PoE Plus
IEEE 802.3at
Classification Ad Hoc
Extended Classification Using
Two Classification Events

Clay Stanford
Linear Technology
July 17, 2007
San Francisco

Revised Specificiaton

Graphical Depiction of Problem

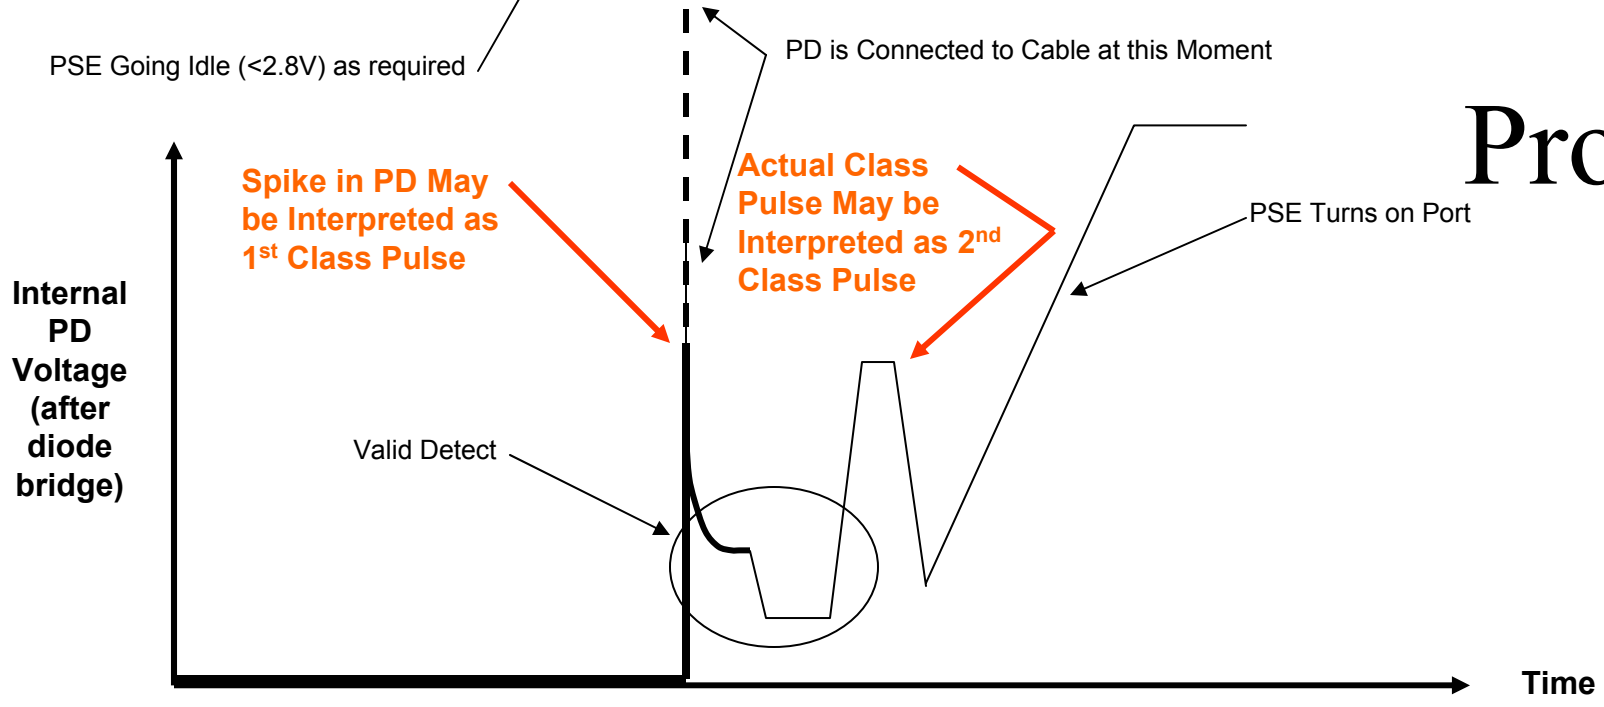
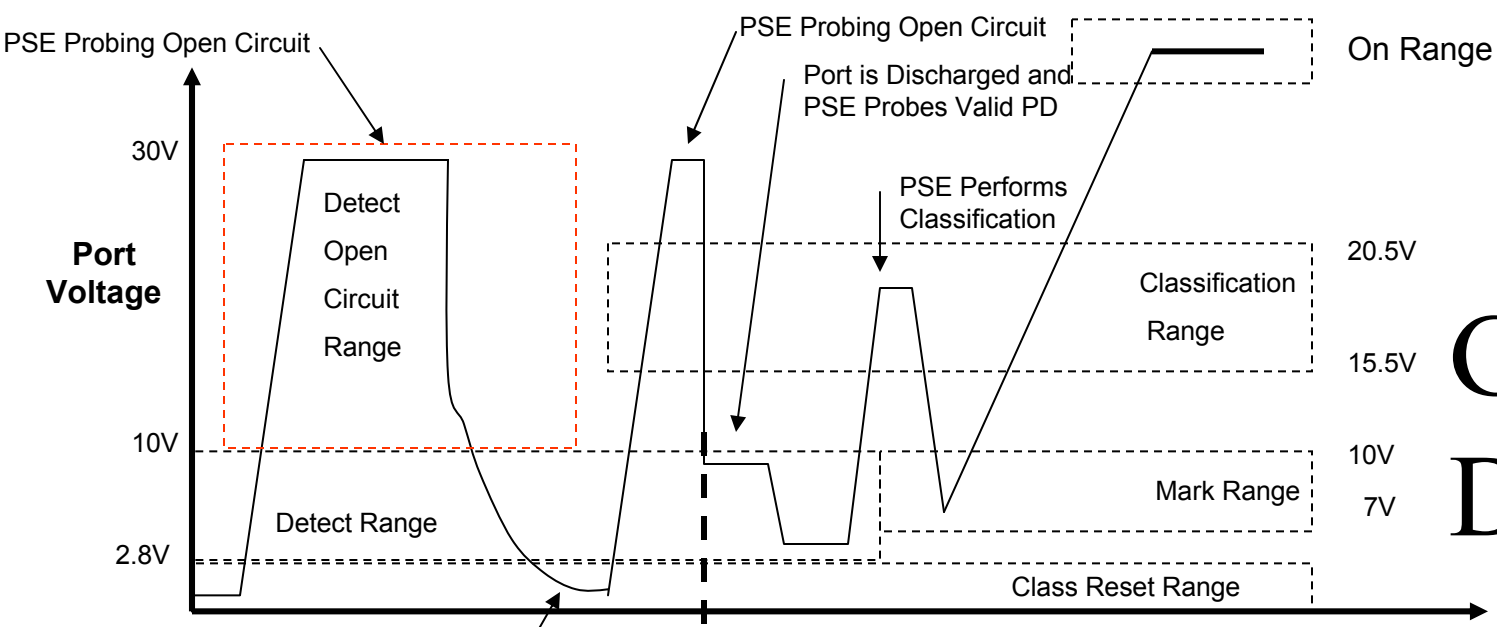
- The proposed 2-Event Classification protocol has a problem:
 - Using a compliant Type 1 (802.3af) PSE
 - Using a compliant Type 2 (802.3at) PD
 - When a Type 2 PD is plugged into a Type 1 PSE, possible for PD to incorrectly interpret waveform as the 2-Event Classification mechanism

- When a PSE is probing an open circuit, port voltage can go to 30V (Table 33-2, item 1)
- At the moment the Type 2 PD is connected to the cable, internal PD voltage can exhibit a spike similar to a classification pulse (refer to sample waveform)
- This spike can fool the PD state machine into thinking the first classification event has occurred
- After detection, Type 1 PSE may perform classification which would appear to Type 2 PD as the second classification event.
- Type 2 PD would incorrectly conclude that Type 2-Layer 1 PSE is present

- Do Not Allow 25K During Mark
 - PSE would fail detection during Mark period
 - PSE would return to Idle State ($V_{port} < 2.8V$)
 - PD State engine would be reset
 - No false Identification

Worst-Case Open-Circuit Port Model

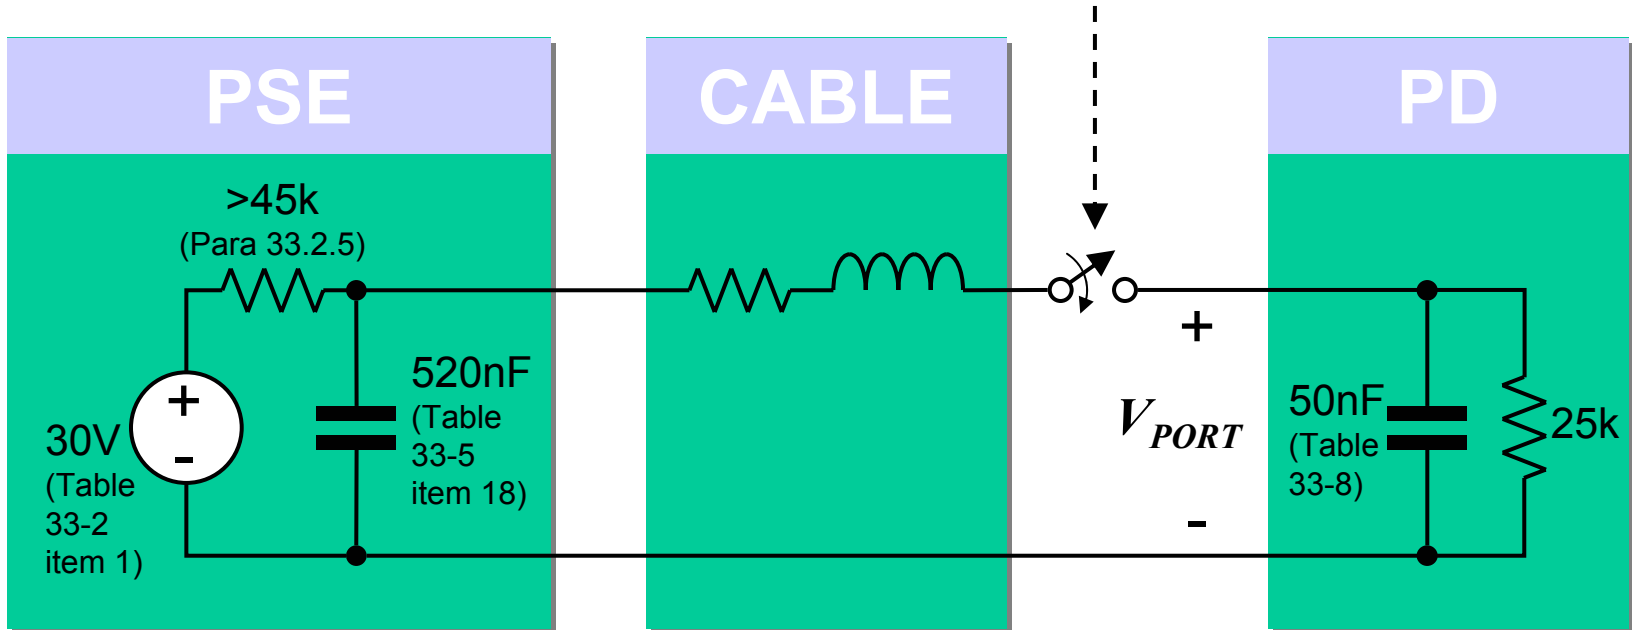
Switch closure represents PD being connected to the end of the cable

Experimental Waveform

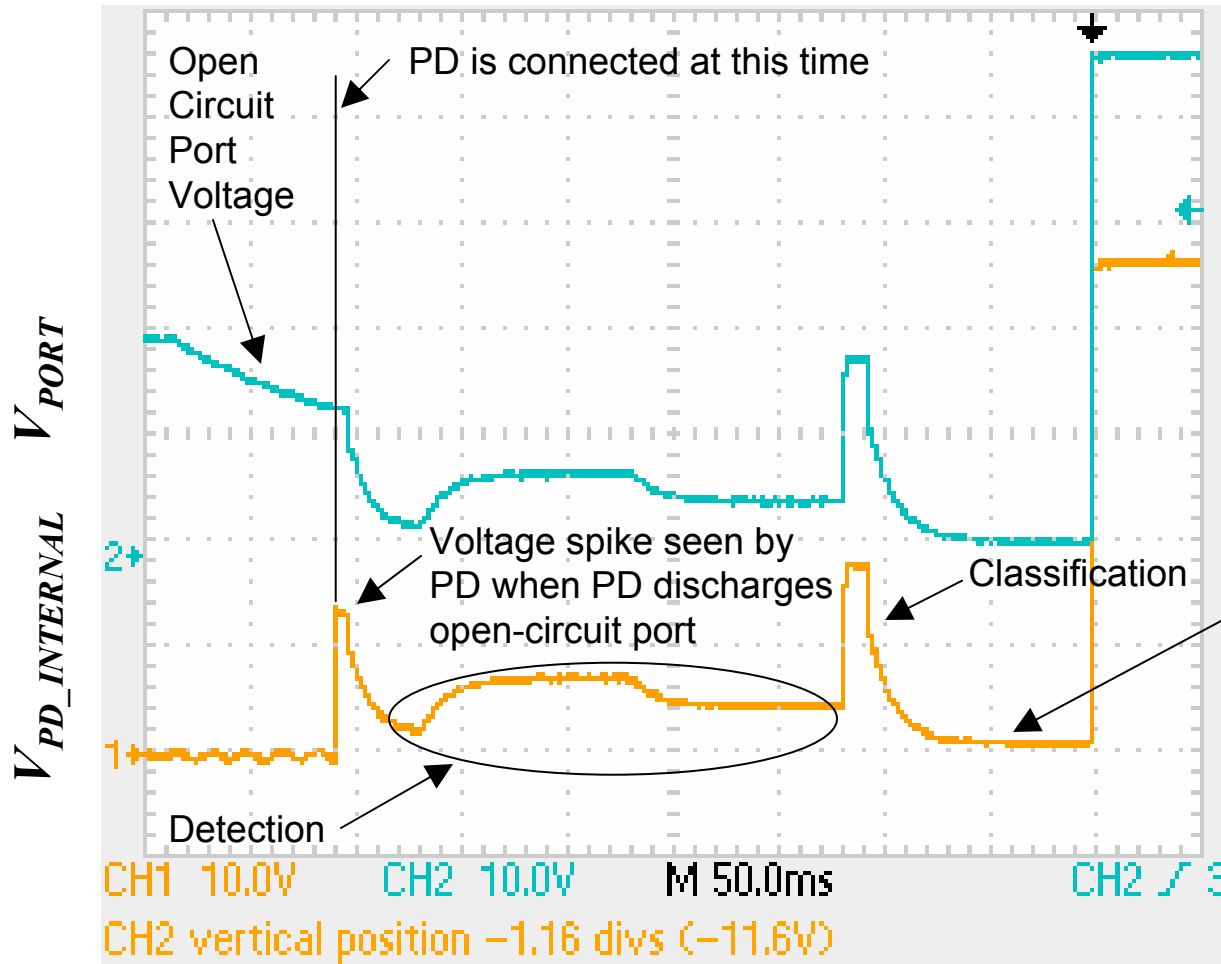
In this example, port goes to 0V which would reset the PD state machine. However, that is not required per IEEE 802.3af

PD State Machine Depends on PSE going to Idle State

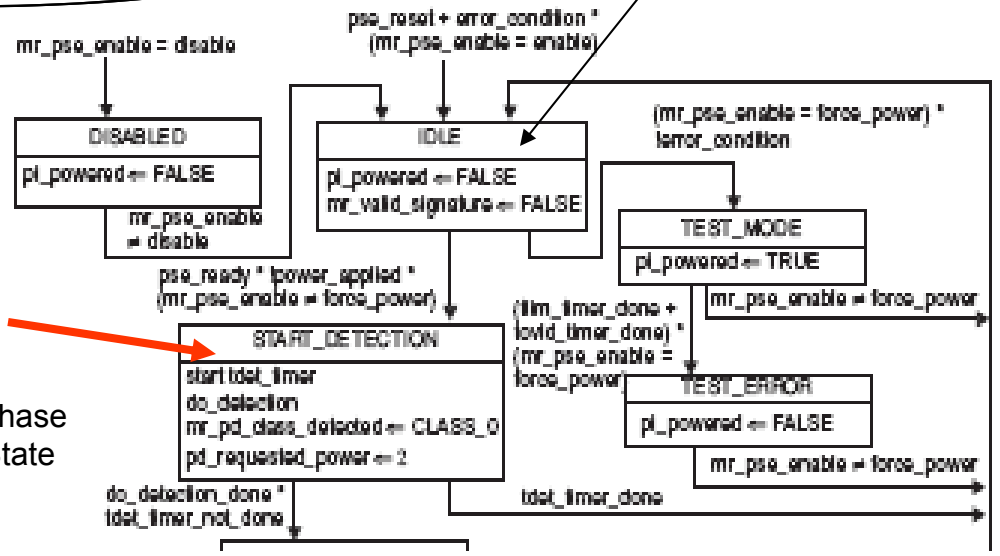
When plugging in PD, possible to Enter PSE State Diagram Here

If PD Plugged in after Idle State and Before Detection Phase 1 is complete, PD can see spike and may not see Idle State (used for PD Reset).

Expanded PSE Classification State Engine

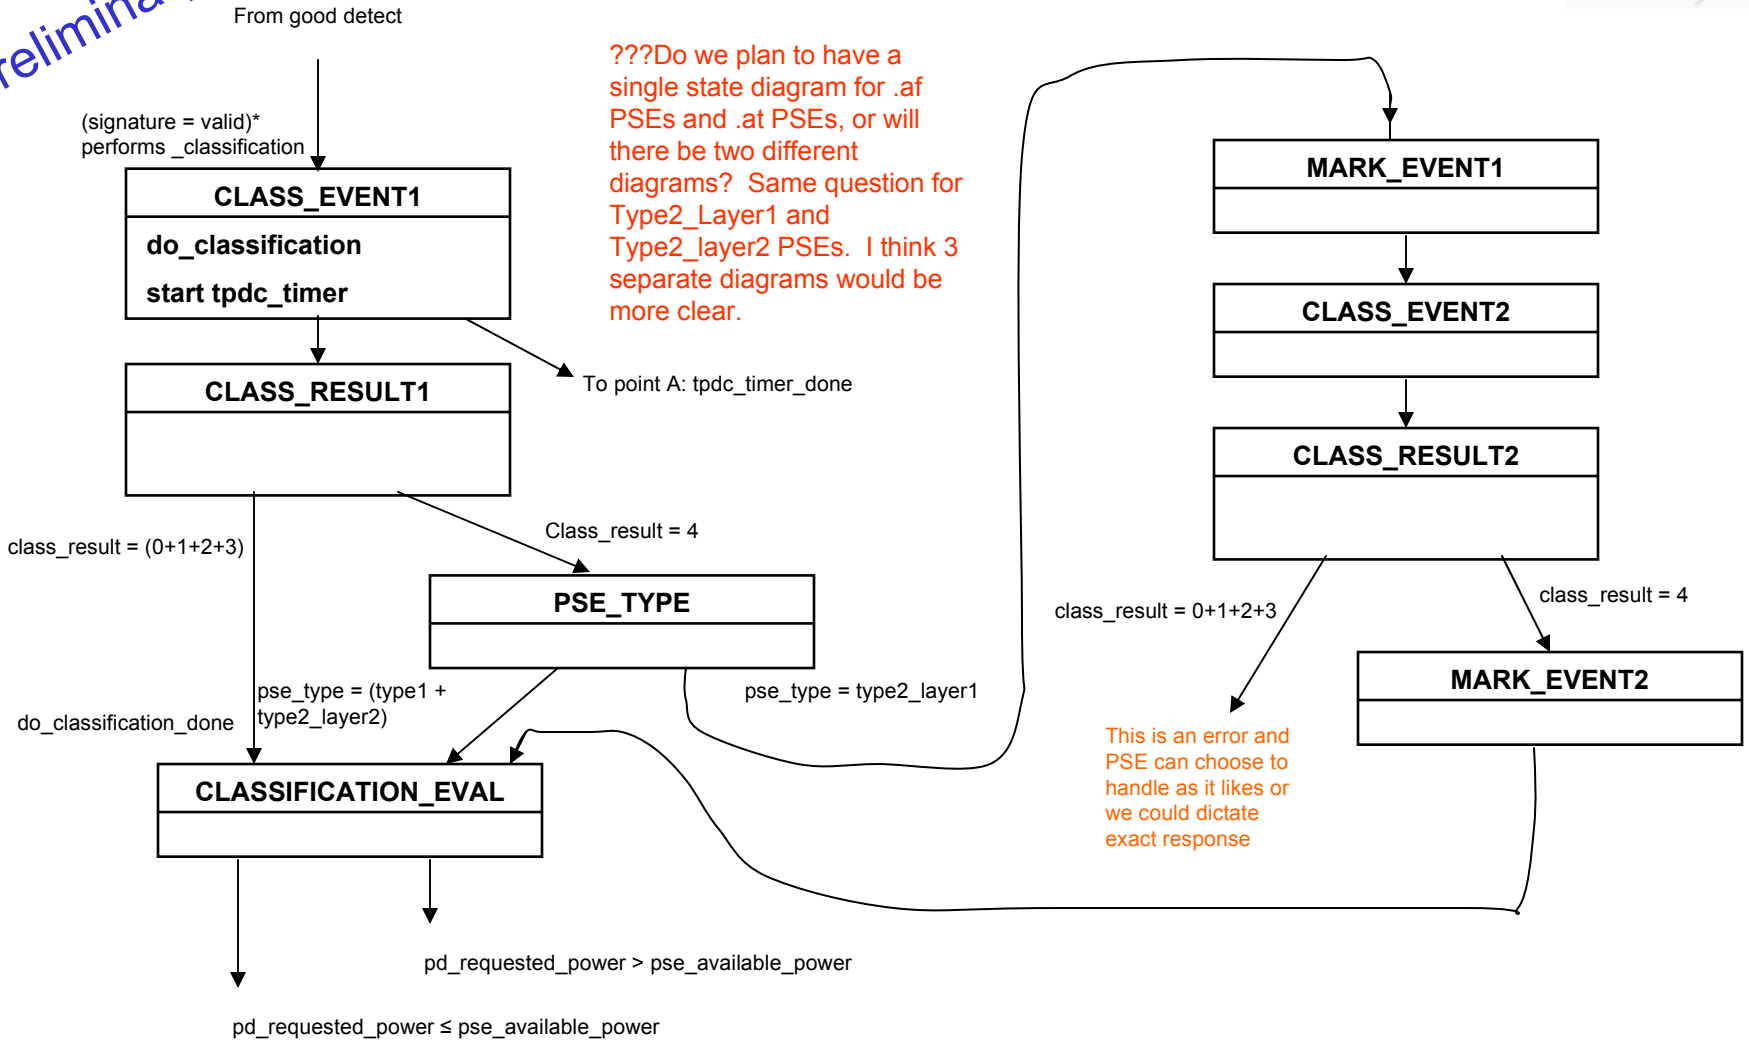
???Do we plan to have a single state diagram for .af PSEs and .at PSEs, or will there be two different diagrams? Same question for Type2_Layer1 and Type2_layer2 PSEs. I think 3 separate diagrams would be more clear.

Expanded PSE Power-On State Engine

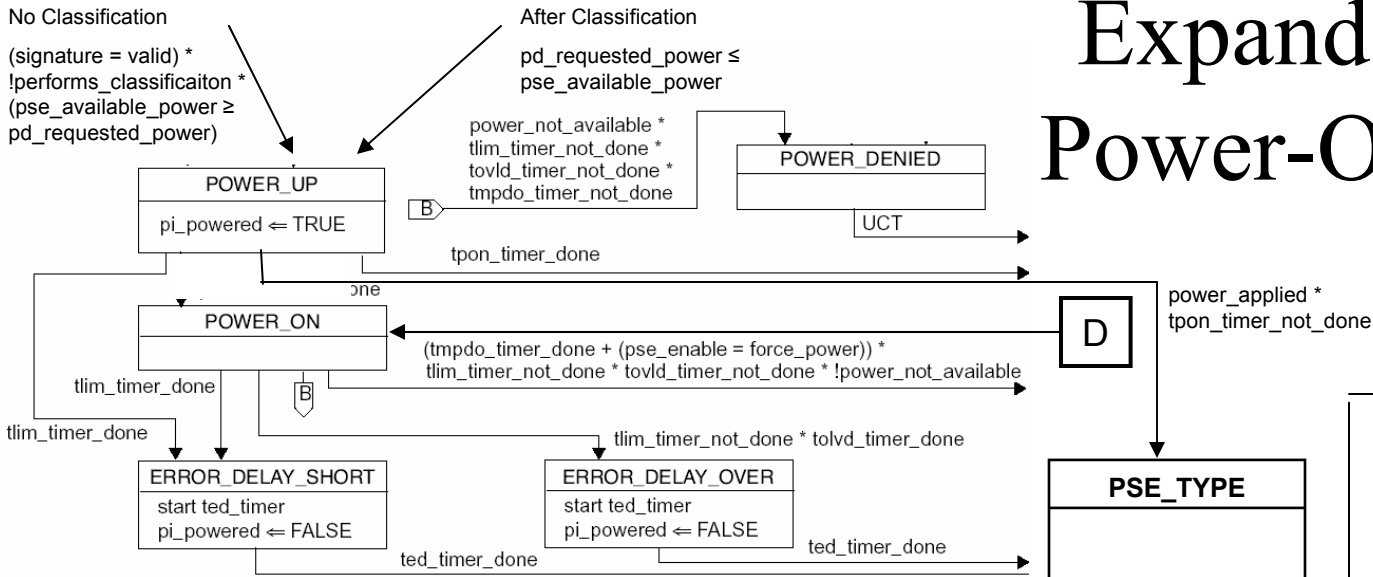
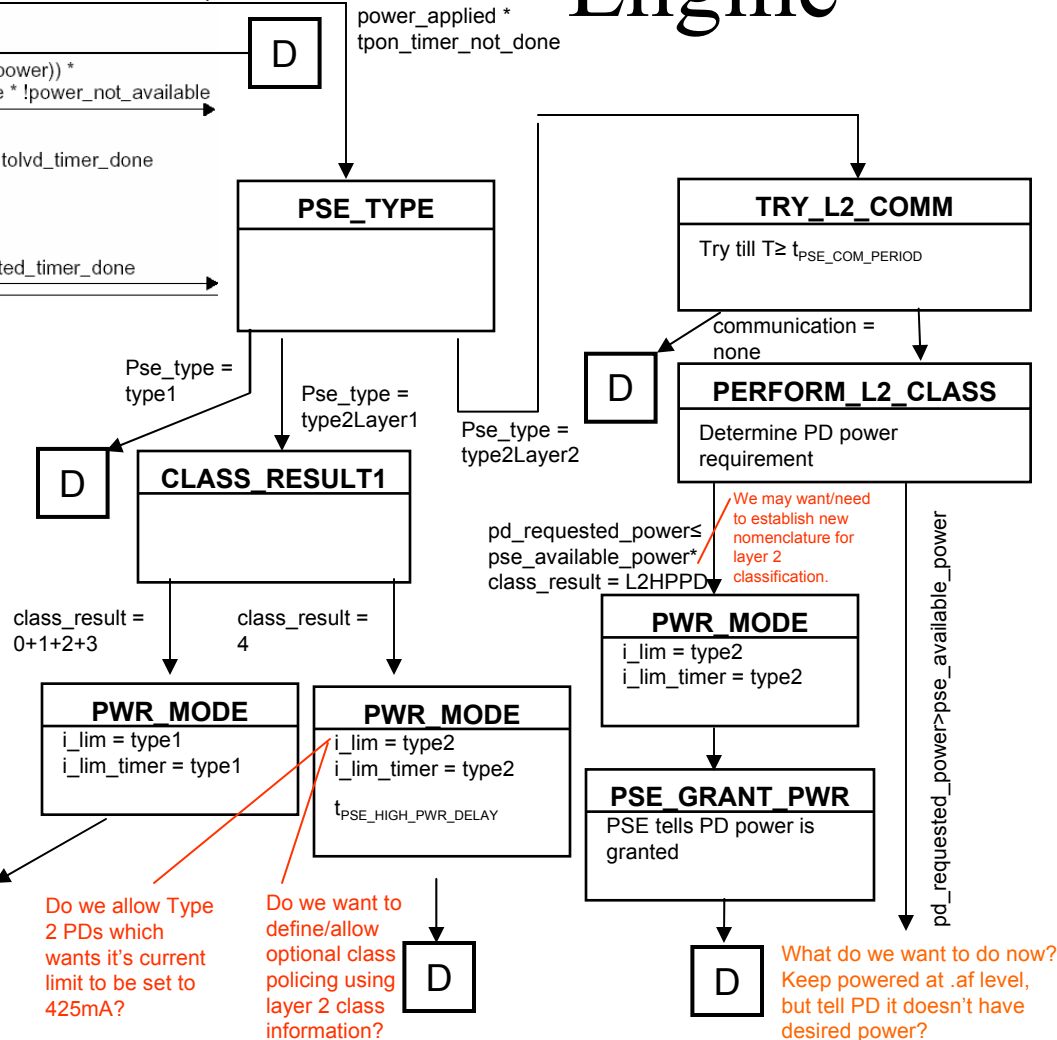
We need to define some new timing parameters. I would propose:

$t_{PSE_HIGH_PWR_DELAY} = 100ms \text{ max}$

Defined from point $V_{port} \geq 50V$ until Current Limit is switched from type 1 (.af) to type 2 (.at) mode

$t_{PD_HIGH_PWR_DELAY} = 100ms \text{ min}$

Defined from point $V_{port} \geq 41V$ until PD draws > 12.95W

$t_{PSE_COMM_PERIOD} = 5sec \text{ min}$

$t_{PD_COMM_BOOTUP} = 4sec \text{ max}$
